## DSP-17050

Application	General Data	
<p><b>Project Name:</b> Iglesia Roca de le Eternidad</p> <p><b>Location:</b> On the south side of MD 450 (Annapolis Road), in the southwestern quadrant of the intersection of MD 450 and 69th Avenue.</p> <p><b>Applicant/Address:</b> Iglesia Roca de la Eternidad Herber Paredes 4610 69th Avenue Landover Hills, MD 20784</p> <p><b>Property Owner:</b> Same as applicant</p>	Planning Board Hearing Date:	06/14/18
	Staff Report Date:	06/07/18
	Date Accepted:	03/28/18
	Planning Board Action Limit:	06/14/18
	Plan Acreage:	6.47
	Zone:	R-55/D-D-O
	Dwelling Units:	N/A
	Gross Floor Area:	23,260 sq. ft.
	Planning Area:	69
	Council District:	03
	Election District	02
	Municipality:	Landover Hills
	200-Scale Base Map:	205NE06

SUBJECT: Detailed Site Plan DSP-17050  
Type 2 Tree Conservation Plan TCP2-001-08-01  
Iglesia Roca de le Eternidad

# SITE PLAN

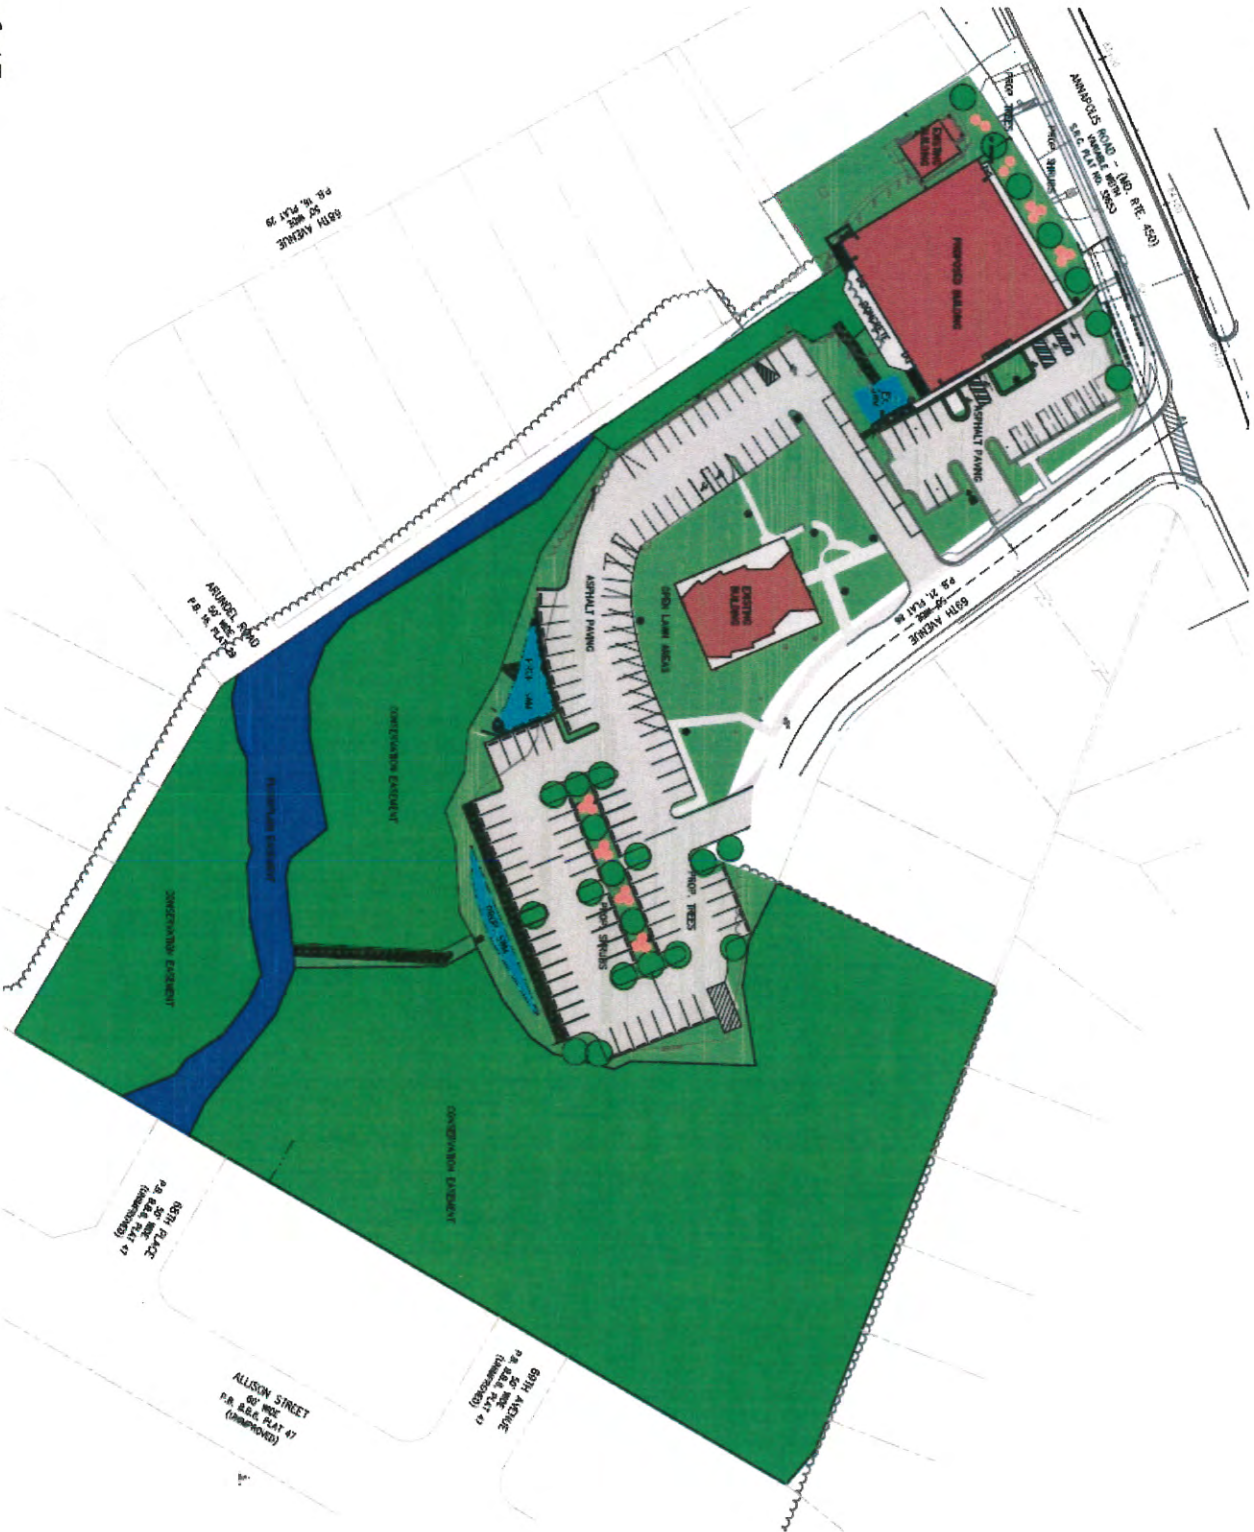
- \*\*\* It is noted that the DSP calculated the total number of spaces incorrectly and this should be revised to indicate the correct number of required spaces. Therefore, a condition has been added to the Recommendation section of this report requiring the applicant to revise the parking schedule to show the required number of parking spaces.

- \*\*\*\*\* The DSP is shows six handicap-accessible parking spaces on the site plan, but these spaces are not shown in the parking schedule. The number of handicap-accessible spaces should be shown in the parking schedule for clarification. Therefore, a condition has been added to the Recommendation section of this report requiring the applicant to revise the parking schedule to show the number of required and proposed handicap-accessible spaces.

The site plan shows 141 parking spaces, which is between the minimum and maximum parking spaces allowed for the site as determined by the Central Annapolis Road Sector Plan and SMA. The parking capacity shown on the site plan conforms to the parking standards for the site, and staff notes that the applicant does not need an amendment for this standard. However, the Parking table shown on the site plan should be revised to show the correct total number of parking spaces.

The landscape plan shows landscaping with two-foot-high shrubs and shade trees along MD 450, along the north elevation; however, no shrubs are shown to screen the parking lot along MD 450.

The development district standards require a brick, stone, or finished-concrete wall, between three and four feet tall to screen the parking lot, and a minimum four-foot-wide landscape strip. The landscape plan should be revised to show a wall along the MD 450 frontage to screen the parking lot.

It is noted that the site plan does not clearly show the location of the required bicycle rack, as conditioned, and the plan should be updated to provide this. Therefore, a condition has been included in the Recommendation section of this report requiring that the applicant revise the site plan to clearly show the location of the bicycle rack, accommodating a minimum of five bicycles, and revise the parking schedule to show the five bicycle parking spaces.

It is noted that full cut-off optic light fixtures are proposed on this site; however, a photometric plan was not submitted with this application. Therefore, a condition has been included in the Recommendation section of this report requiring that the applicant submit a photometric plan with the DSP, at the time of certification, demonstrating that appropriate lighting levels are being proposed and that there is no light spill-over onto adjacent properties.

1. Prior to certification of the detailed site plan (DSP), the plans shall be revised, as follows:
    - a. Mark and label a location for a bicycle rack, accommodating a minimum of five bicycles, at a location convenient to the multipurpose sanctuary. A detail for the bicycle rack shall be included on the plan.

- d. Revise the parking schedule to show the five bicycle parking spaces.
    - e. Provide a photometric plan demonstrating that appropriate lighting levels are being proposed and that no light spill-over onto adjacent properties is occurring.

- f. Correct the parking schedule to show the total required number of parking spaces.
    - g. Revise the parking schedule to show the number of required and provided handicap-accessible spaces.

- h. Revise the site plan to provide a loading area, as required by Section 27-582 of the Prince George’s County Zoning Ordinance.
    - i. Revise the site plan and the Tree Canopy Coverage schedule to show conformance with Section 25-128 of the Prince George’s County Code.

- o. Clearly identify the van-accessible handicap parking spaces.
  - p. Revise the landscape plan to provide a wall and landscaping along MD 450 (Annapolis Road) to screen the parking lot, in accordance with the development district standard.

# NORTH ELEVATION

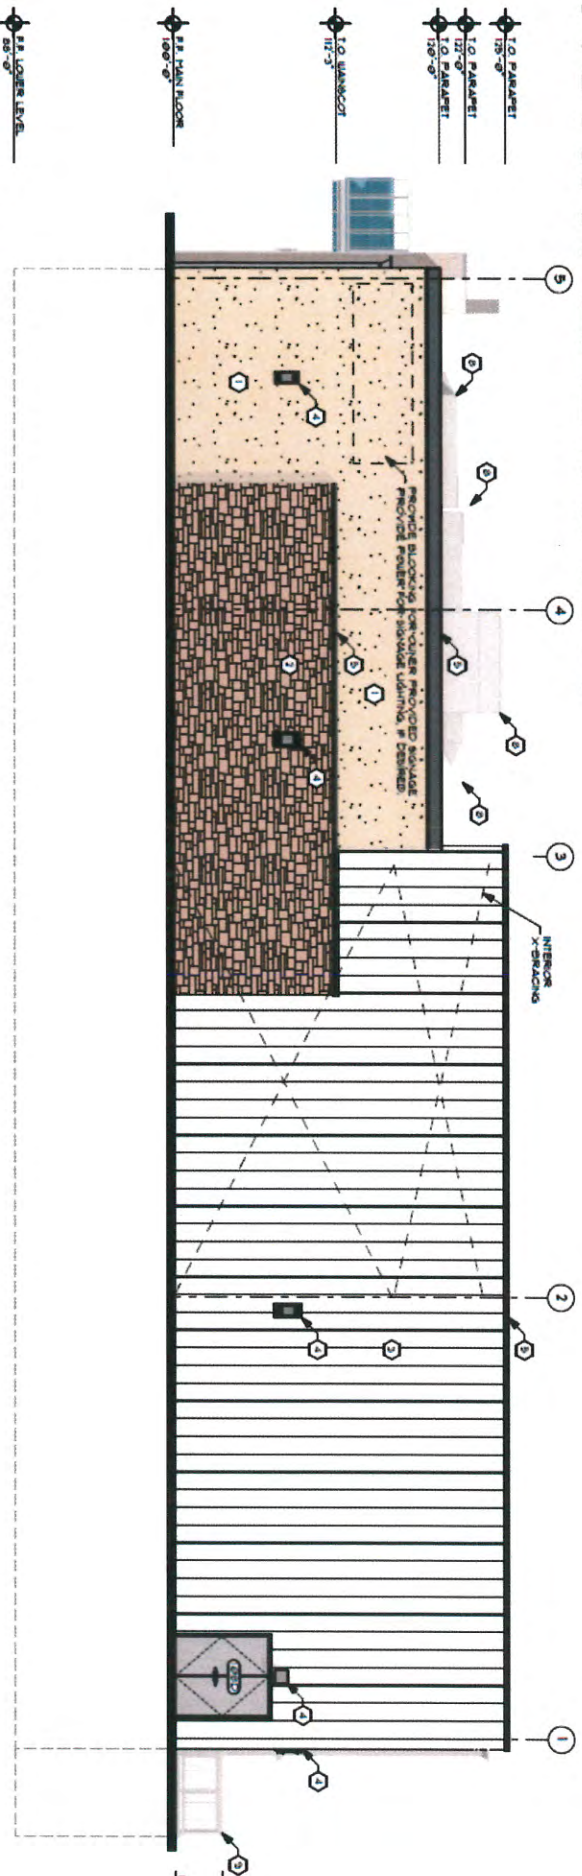
Due to the building placement on MD 450, staff recommends that the side elevation of the building along this road be designed to include additional architectural features, so it is equal to the front elevation in terms of quality of materials and detailing, as required by Standard II.D.(2)(d.). Therefore, a condition has been included in the Recommendation section of this report requiring the applicant to provide additional architectural features on the side elevation of the building facing MD 450.

- s. Provide additional architectural features on the side elevation of the building facing MD 450 (Annapolis Road).
  - t. Revise the northern and western building elevations to incorporate higher quality building materials such as brick, decorative masonry, or decorative metal.
